ECE/TRANS/WP.29/2010/30
18 December 2009

Proposal for Supplement 6 to Regulation No. 99
(Gas-discharge light sources)

Submitted by the Working Party on Lighting and Light-Signalling */

Sheet DxR/1

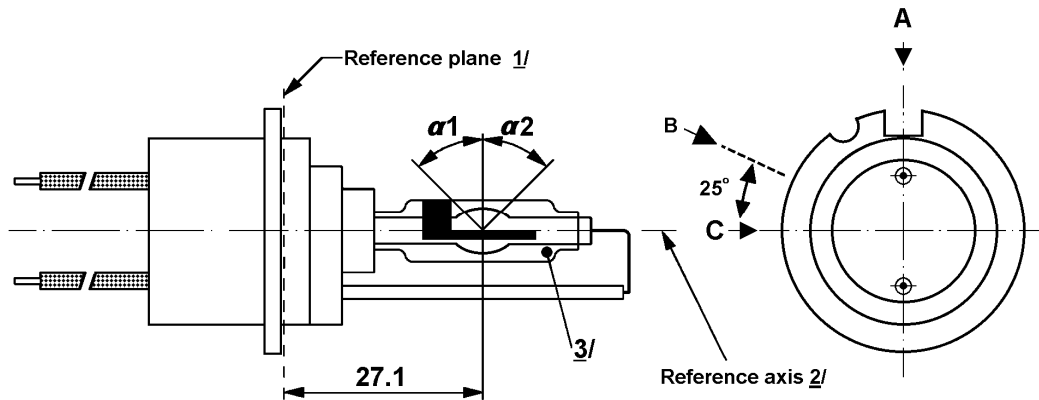
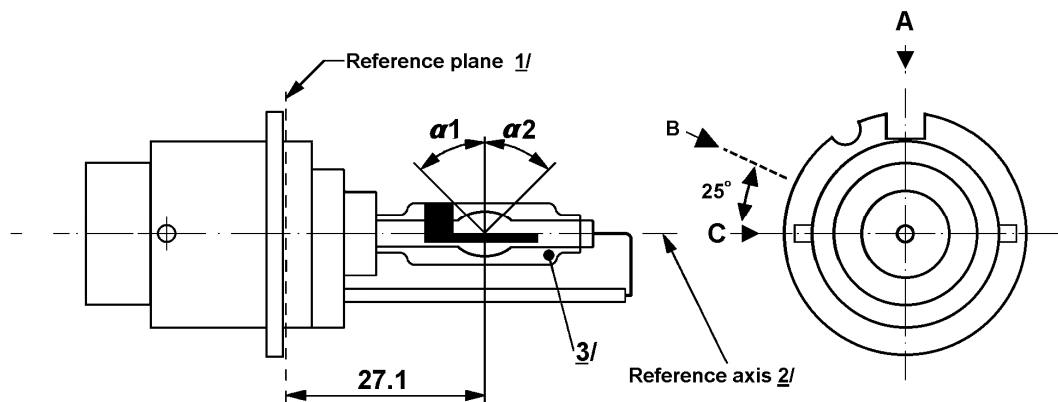
Sheets DxR/1 to 3 and DxR/6, replace by new sheets, to read (see next pages):

- 1/ The reference plane is defined by the positions on the surface of the holder on which the three supporting bosses of the cap ring will rest.
- 2/ See sheet DxR/3.
- 3/ With respect to the reference axis, when measured at a distance of 27.1 mm from the reference plane the eccentricity of the outer bulb shall be less than ± 0.5 mm in direction C and less than $- 1$ mm /+ 0.5 mm in direction A.

Figure 1 - Category D1S - Type with cables - Cap PK32d-2

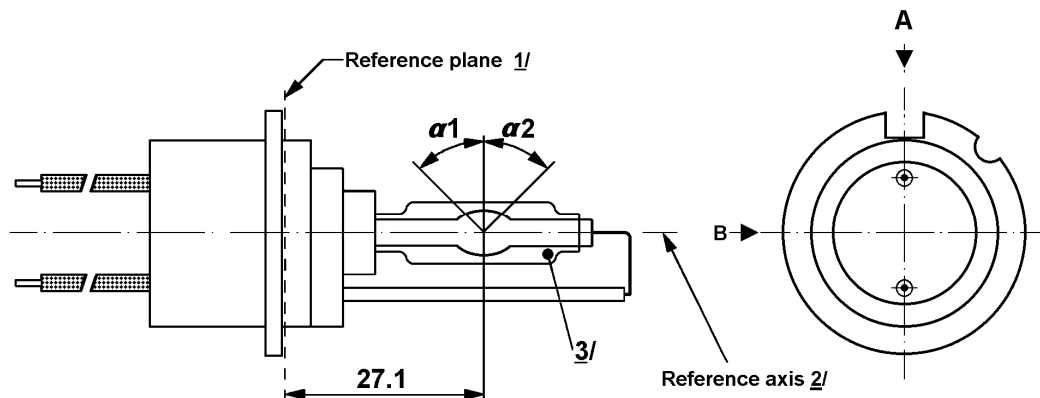
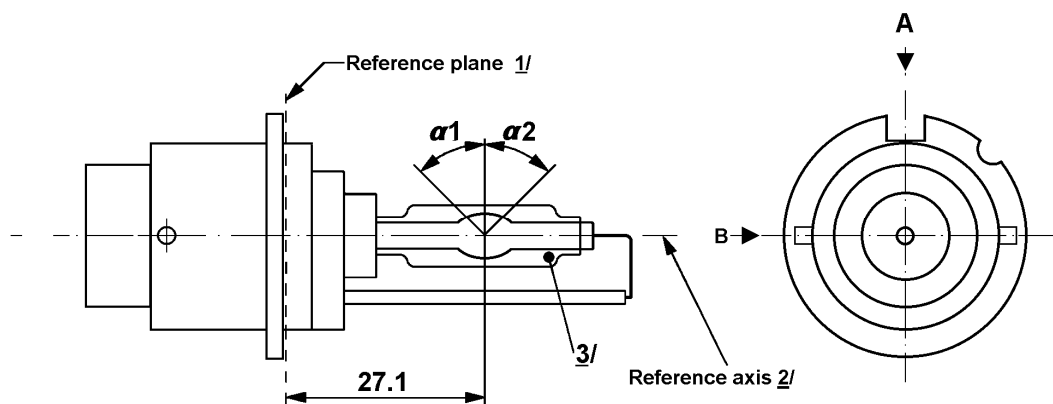
Sheets DxS/1 to 3 and DxS/6, replact by new sheets, to read (see next pages):

- 1/ The reference plane is defined by the positions on the surface of the holder on which the three supporting bosses of the cap ring will rest.
- 2/ See sheet DxS/3.
- 3/ When measured at a distance of 27.1 mm from the reference plane and with respect to the mid-point of the inner bulb, the outer bulb shall have an eccentricity of 1 mm max.
